22-14SE & 22-30SP Nokomis Groves Staff Report

Address:	Northeast quadrant of Knights Trail Rd and Gene Green Rd
Requests:	SP: Development of 630 multi-family units with amenities, landscaping, and associated improvements SE: To allow for development of multi-family within the Commercial, General District (CG) & for reduction of required parking spaces
Owner/Applicant:	CSP-Grand Oaks Venice Land I, LLC, & the Edwards Family Partnership
Agent:	Jackson R. Boone, Esq., Boone Law Firm
Parcel ID:	0366003010, 0366003011, 0366003020
Parcel Size:	53.27 ± acres
Future Land Use:	Mixed Use Corridor
Zoning:	Commercial, General (CG)
Comprehensive Plan Neighborhood:	Knights Trail
Application Date:	SP: May 4, 2022; SE: March 8, 2022
Related Applications:	Zoning Petition 22-13RZ; Conditional Use Petition 22-32CU

Site Plan

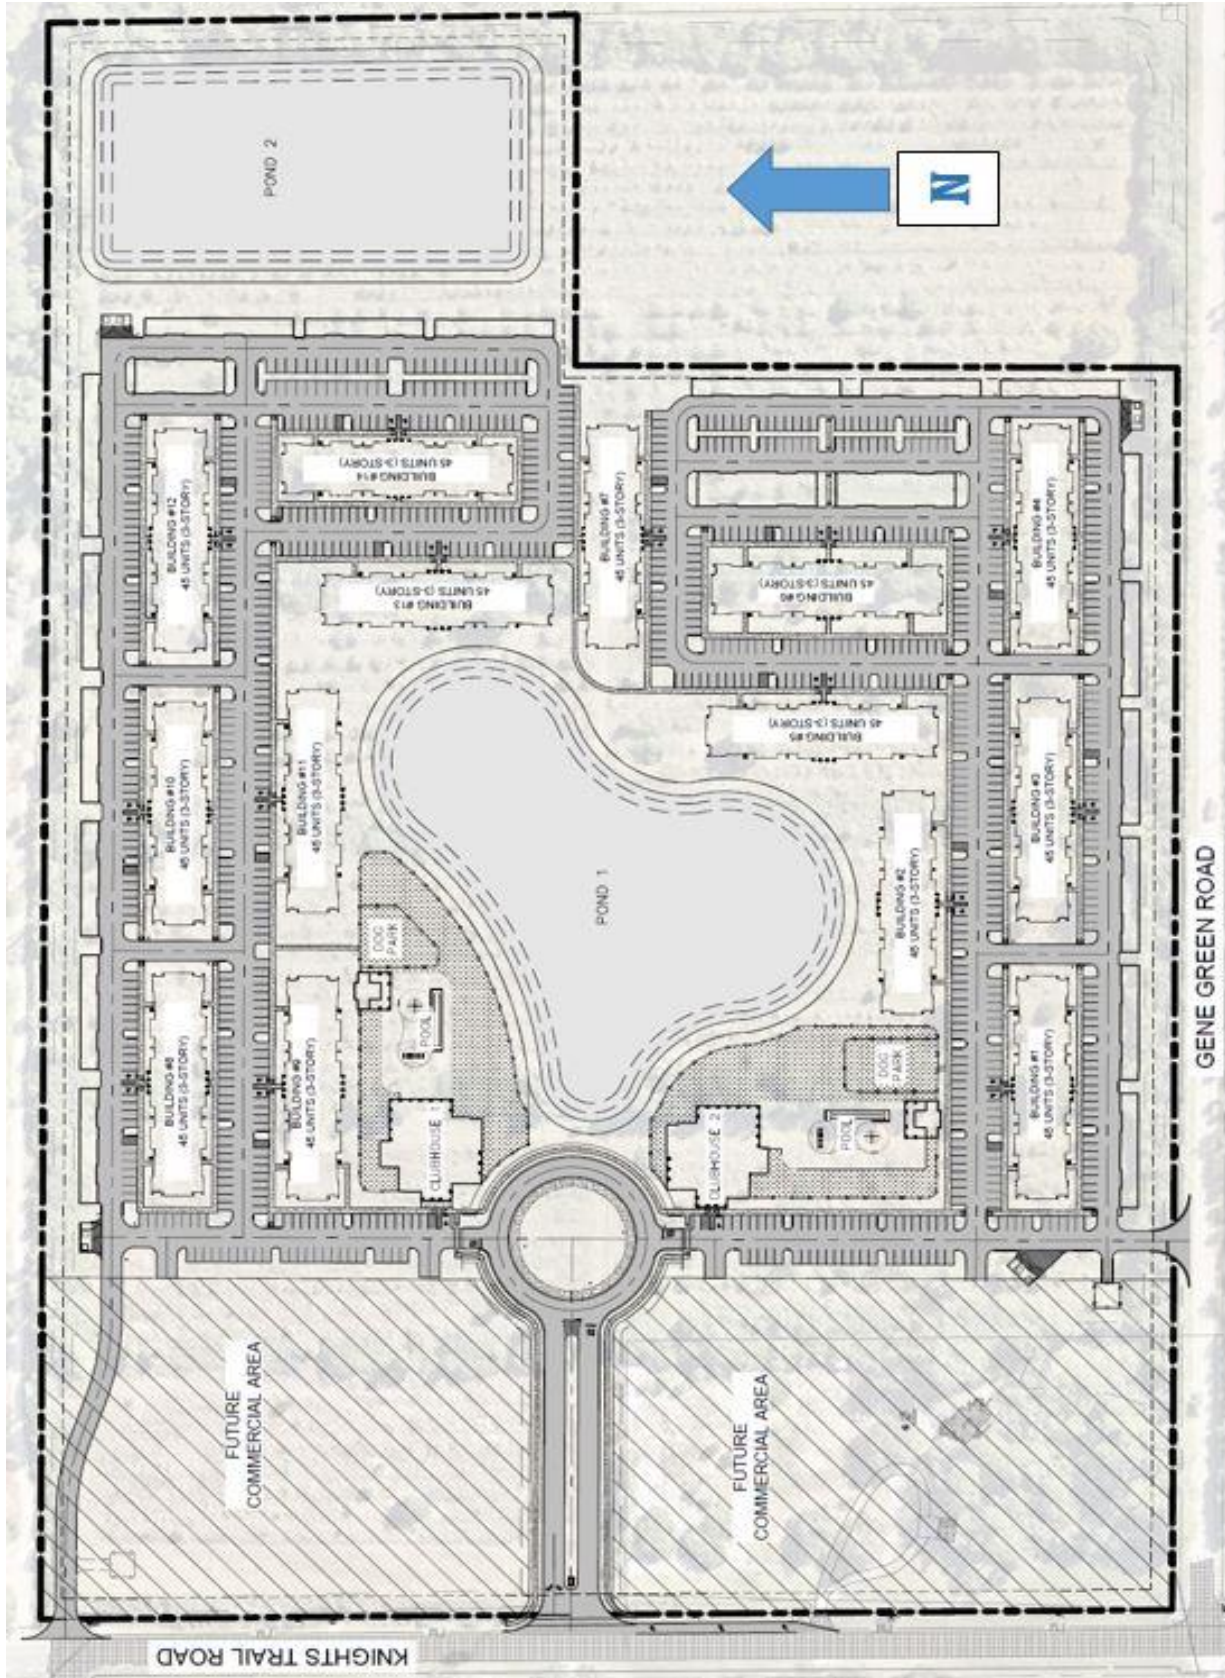
Staff Comment: Density for this project is within the limits set by the Comprehensive Plan. Adjacent and nearby properties are screened by garages and landscaping.

Staff Comment: Two access points are being provided to Knights Trail Road and an emergency access will be on Gene Green Road. Sidewalks are proposed within the development and linking the multi-family to the sidewalk on Knights Trail Road.

Staff Comment: There will be perimeter landscape buffering with this project. The multi-family buildings will be located more centrally on the site with garages, surface parking, and landscaping between the residential and surrounding properties.
